Industry's comments on UNR157-07-06

OICA/CLEPA

July 7, 2021

Safety Check Process

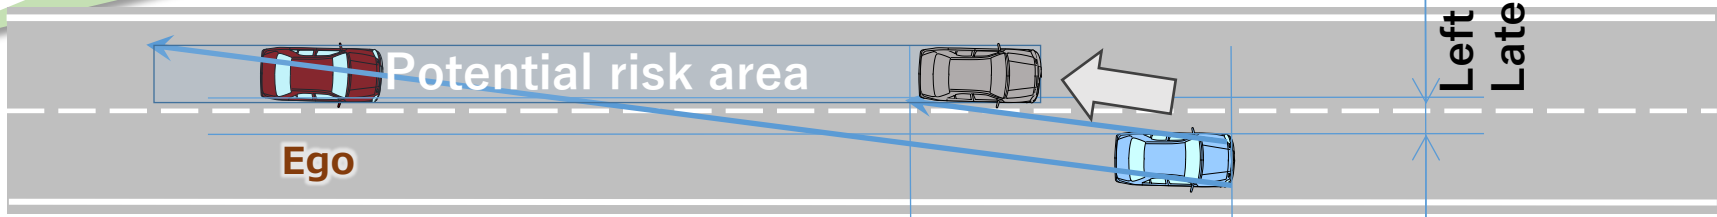
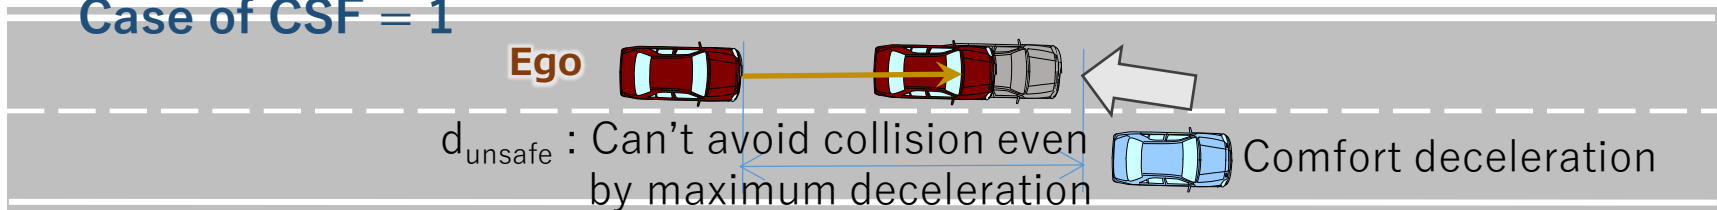
Check the potential risk of collision

Right term: Longitudinal travel time + 0.1 Sec.

Left term: Lateral travel time

FSM's lateral safety check would induce unnecessary braking in the natural wandering cases in real traffic.

Comparison of Wandering vs Cutting-in of human driver

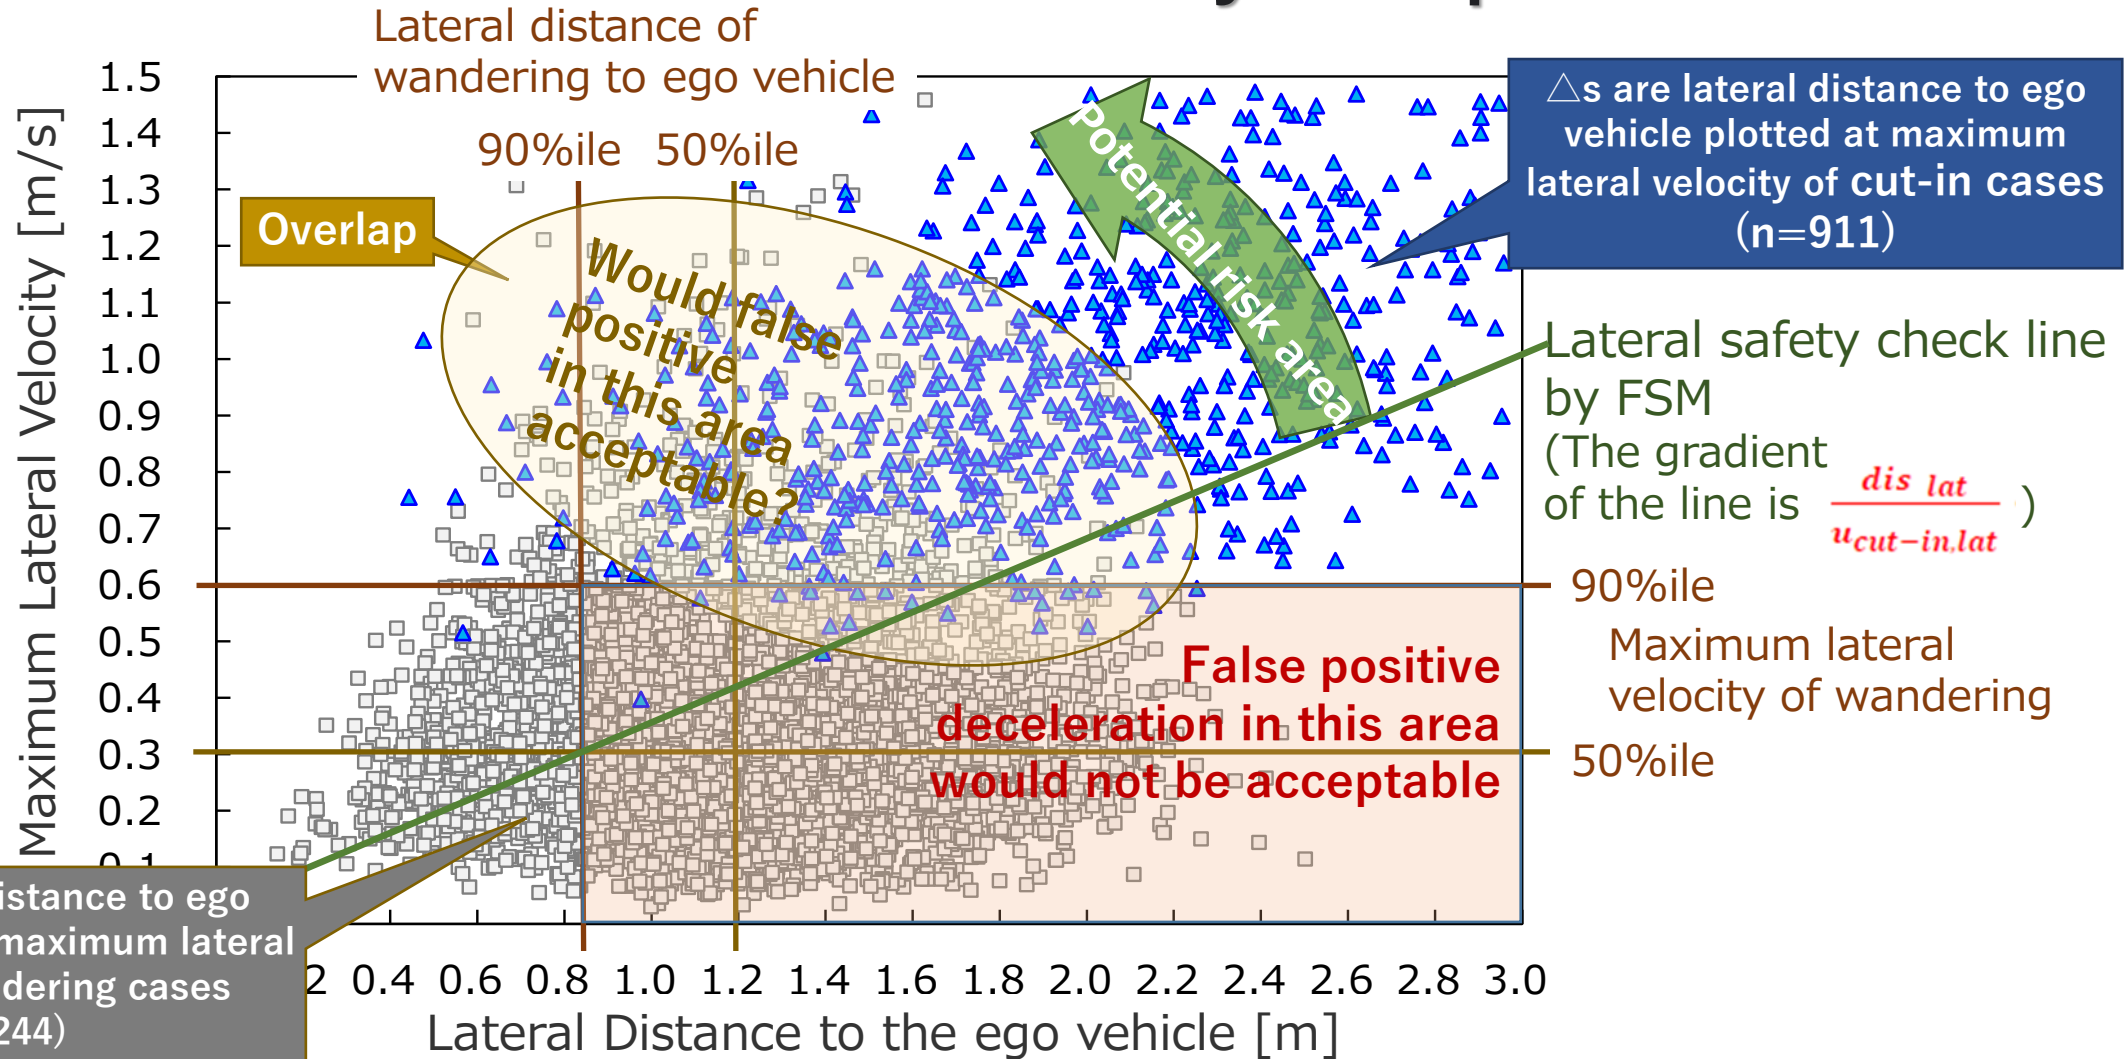
Natural human drivers are wandering during lane keeping
Median of Lateral velocity \cong 0.3m/s, Median of Wandering width \cong 0.75m

Distribution of maximum lateral velocity & its position

False positives assessment

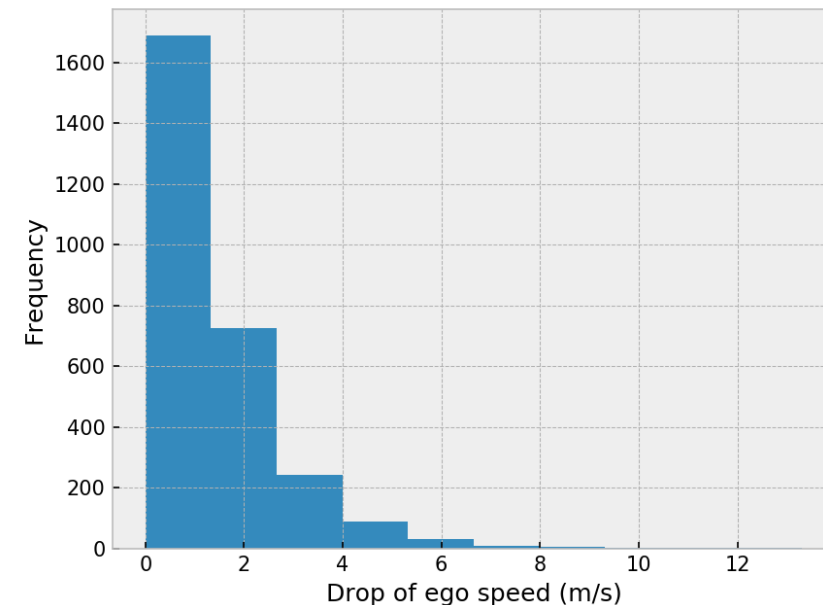
- Concerns were raised about the possibility that the model would require **too many false positive decelerations in order to achieve a lower number of unpreventable scenarios** compared to the existing performance models
- The highD was used to test false positive cases as well
 - We extracted all trajectories where two vehicles are proceeding in two different lanes without changing lane -> **158,394 observations**

- Results
 - Due to the lateral movements of the vehicle in the adjacent lane the FSM required a mild deceleration of the ego vehicle in 2,802 cases (1.51%)
 - Only in about 300 cases (0.18%) the drop in velocity was bigger than 2 m/s
 - In less than 50 (0.03%) cases it was bigger than 5 m/s
- These types of speed drops can be explained by a driver **removing the foot from the acceleration pedal** which is compatible with the strategy of a competent and careful human driver
- **Conclusion: false positives do not seem to represent a major issue for the model**

These false positives are not acceptable because;

- ✓ **Pretty big number of unnecessary decelerations were observed**
- ✓ **They could cause safety critical situations in natural flow of traffic**

- Due to the lateral movements of the vehicle in the adjacent lane the FSM required a mild deceleration of the ego vehicle in **2,802 cases (1.51%)**
⇒ **FSM triggered unnecessary deceleration almost as many as actual cutting-ins**
- Only in about **300 cases (0.18%)** the drop in velocity was bigger than 2 m/s
⇒ **FSM triggered significant unnecessary deceleration almost 10% of actual cutting-ins and its deceleration level was not declared in UNR157-07-06**
- In less than **50 cases (0.03%)** it was bigger than 5 m/s
⇒ **FSM triggered unnecessary harsh deceleration almost 2% of actual cutting-ins and the deceleration level must have been at least 4m/s^2**

Conclusion: False positives caused by FSM are significant safety issues and not acceptable for customers as well ⇒ Need further investigation
